# REVISED RESPONSE TO REQUEST FOR ADDITIONAL INFORMATION

#### **APR1400 Design Certification**

Docket No. 52-046

RAI No.: 71-7906

between redundant divisions of the Class 1E equipment listed in Table 2.5.1-1

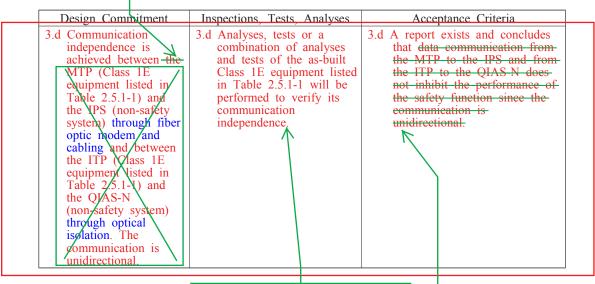
Demonstrate that communications independence requirements will be met for communications between redundant divisions of Class 1E equipment and between non-safety systems and Class 1E equipment. In addition, the design commitment for communication independence and ITAACs needs to include sufficient design descriptions in order to meet the requirements of 10 CFR 52.47(b)(1).

APR1400 FSAR, Tier 1, Section 2.5.1.1, "Design Description," Item 3.c states, "Communication independence is achieved between redundant divisions of the Class 1E equipment listed in Table 2.5.1-1 or between non-safety systems and the Class 1E equipment listed in Table 2.5.1-1." This design commitment implies that communication independence will be achieved either between redundant divisions of Class 1E equipment or between non-safety systems and Class 1E equipment. The staff believes the wording should be modified to "Communication independence is achieved between redundant divisions of the Class 1E equipment listed in Table 2.5.1-1 and between non-safety systems and the Class 1E

equipment listed in Table 2.5.1-1" in order to demonstrate that communications independence will be achieved between redundant divisions of Class 1E equipment and between non-safety systems and Class 1E equipment. Further, the design commitment and the associated ITAACs do not provide sufficient design information to demonstrate how communications independence will be achieved in the as-built system (e.g. types of communications faults that will be mitigated, key safety I&C features that will be used to mitigate these faults) in order to meet the requirements of 10 CFR 52.47(b)(1). For instance, the design description and the ITAAC should be more specific as to how communication independence is achieved for the various interdivisional communication links. The staff did not find ITAACs to verify the unidirectional gateway between the maintenance and test panel (MTP) and the information processing system (IPS), and between the integrated test panel (ITP) and qualified information and alarm system - non-safety (QIAS-N) in order to verify that communications independence is achieved between safety and non-safety systems. Modify Tier 1 of the FSAR, including the ITAAC to resolve these issues.

Delete			1-5 (3 of 10) nodem and cabl	ina	independence	
		Design Commitment		Γests, Analyses		Acceptance Criteria		
	3.c	Communication independence is achieved between redundant divisions of the Class 1E equipment listed in Table 2.5.1-1 or between nonsafety systems and the Class 1E equipment listed in Table 2.5.1-1.	3.c Analyses, tests or a combination of analyses and tests of the as-built Class 1E equipment listed in Table 2.5.1-1 will be performed to verify its communication independence.		3.c A report exists and concludes that data communication between redundant divisions of the Class 1E equipment listed in Table 2.5.1-1 or between non-safety systems and the Class 1E equipment listed in Table 2.5.1-1 does not inhibit the performance of the safety function.		Dele Del	
<i>→</i>	4.a	The RTS provides an automatic reactor trip (RT) and ESF initiation signals, as indicated in Tables 2.5.1-2 and 2.5.1-3, if plant process signals reach predetermined setpoints.	4.a	will be per	he as-built PPS formed using test signals.	4.a	Each as-built RTSS opens upon receipt of the automatic reactor trip signal identified in Table 2.5.1-2 from respective division of the as-built RTS, and asbuilt ESF initiation signals are sent to ESF-CCS upon receipt of the automatic ESF initiation signal identified in Table 2.5.1-3.

- The communication process is performed by a communication processor (CP) separate from the function processor (FP) that executes the RPS and ESFAS function.
- Separate send and receive data channels are used for communication.
- The FP and CP interface only by way of the dual-ported random access memory.
- The FP operates in a strictly cyclic manner.
- The CP transmits signals to serial data link in a deterministic transmit cycle, receives only defined messages, and stores them in a predefined shared-memory.
- The FP and CP detect errors through self-diagnostic function.

communication independence between non-safety systems and Class 1E equipment listed in Table 2.5.1-1 is provided by:

- The data flow from the MTP to the IPS and from the ITP to the QIAS-N is unidirectional via fiber optic cable.
- The MTP and the ITP do not receive any data from the IPS and the QIAS-N (no receiving connection).
- The MTP has separate communication modules for communication processing to provide a buffering circuit between the PPS and the IPS.
- The communication process between the ITP and the QIAS-N is performed by the communication processor (CP) in the ITP.
